Project: Ballarat
North

Exhibition Submission Regarding Draft Ballarat North PSP and DCP (Amendment C256bal)

APD Projects in support from Spiire is pleased to submit this formal response to the exhibition of Amendment C256bal, the draft Ballarat North Precinct Structure Plan (PSP) and Development Contributions Plan (DCP), on behalf of our client, (comprising parcels 36, 37, 40, 43, and 44).

Figure 2: Current PSP Staging

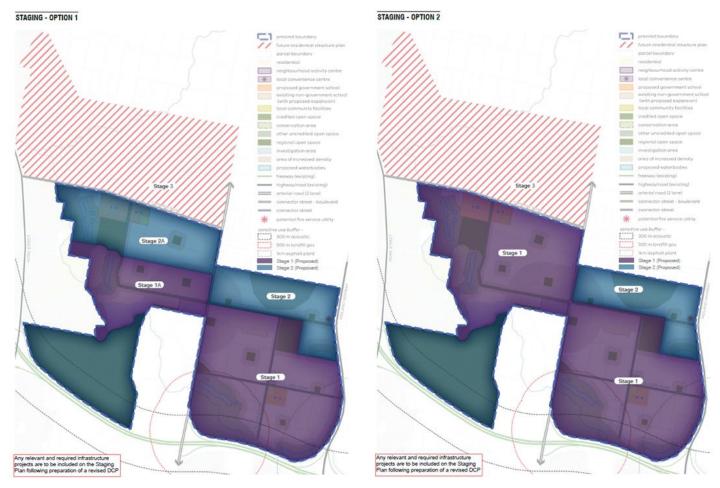
Plan 10 (Infrastructure Development & Staging, shown in Figure 2) proposes a 2-stage approach to development, with upgrades to Gilles Road (RD-01, IN-01, RD-01-2) and Midland Highway all required as Stage 1 works.

As drafted, the PSP will sterilise the development of any part of our landholdings, with no certainty around the circumstances in which development may be supported to be brought forward. While the PSP indicates that out of sequence development may be considered subject to the views of authorities, there is no certainty or flexibility apparent to allow outcomes that are not generally in accordance with Plan 10.

Critical precinct-accessing infrastructure such as Gillies Road should not be contingent upon the development of a limited Stage 1 area. Delays over the acquisition of land for the intersection, a lack of development imperative within the limited number of landowners in Stage 1, or issues that slow progress within that stage now have a PSP-mandated knock-on effect to Stage 2.

- The staging plan is considered unequitable and unnecessarily restrictive from a transport access perspective.
- The base traffic volumes adopted by Jacobs to inform the modelling in the Ballarat North PSP Strategic Transport
 Modelling Assessment Report are over inflated by at least 3000vpd, based on actual traffic counts conducted by
 Ratio Traffic Consultants This has precinct-wide impacts particularly as these volumes have been used to inform
 the staging strategy.

- All road projects are currently contained within existing road reserves and as such could be undertaken by developers in Stage 2 if development in Stage 1 had not triggered the upgrade.

- Clarification is provided as to the rationale of using the base traffic volumes in the Transport Modelling Assessment Report.
- APD has produced two revised staging options (refer Figures 3 and 4 below), both of which seek to expand Stage 1 to enable developers outside the existing Stage 1 to upgrade Gilles Road and initiate development to the west of Gillies Road.
- Both options would require an update to Plan 10, and corresponding notation that the development of Stage 1 to
 the west of Gillies Road requires the delivery of RD-01-2, IN-01 and RD-01-1 to the satisfaction of the Responsible
 Authority prior to SOC (wording to be confirmed). This would have the benefit of ensuring the early delivery of
 Gillies Road upgrades in an expedited manner.

Figure 1: Figure 0-1-1 from the SMEC Drainage Strategy

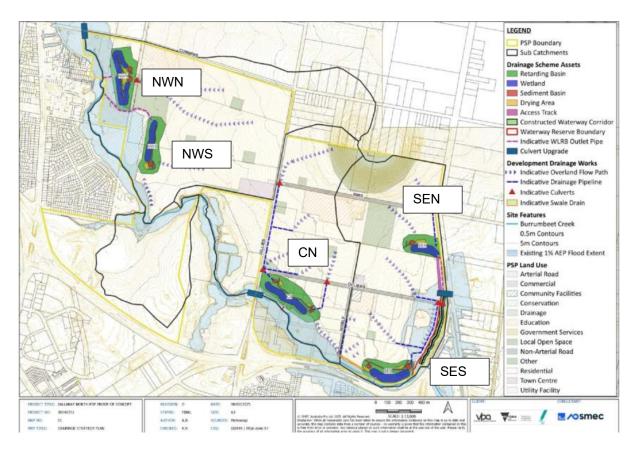
The below extract is Figure 0-1-1 from the SMEC report. This figure shows five proposed wetland / retardation basins (WLRB) located across the PSP. Labels for each WLRB are added for context.

WLRBs are located within three distinct sub-catchments (refer Figure 6 Appendix A). WRLBs SES and SEN are located in the "Southeast" sub-catchment, CS in the "Central" sub-catchment and NWN and NWS located in the "Northwest" sub-catchment.

Figure 15: NW Catchment Active Open Space

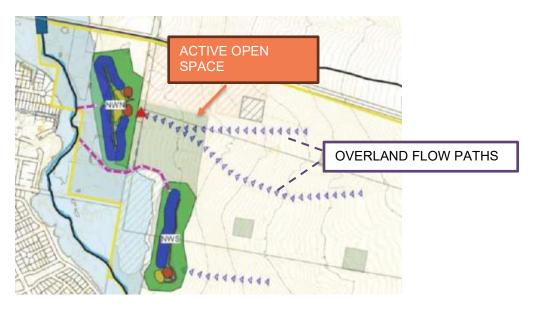
The active open space area in the NW catchment area is located within the two overland flow paths. See extract below. Flow paths should be ideally directed around the active open space.

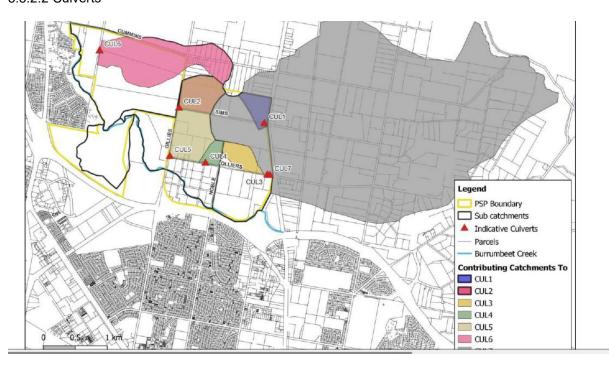
We believe that an additional culvert and / or main drain needs to be considered to adequately convey overland flow from the external catchment to the northeast of the NW catchment at Gillies Road.
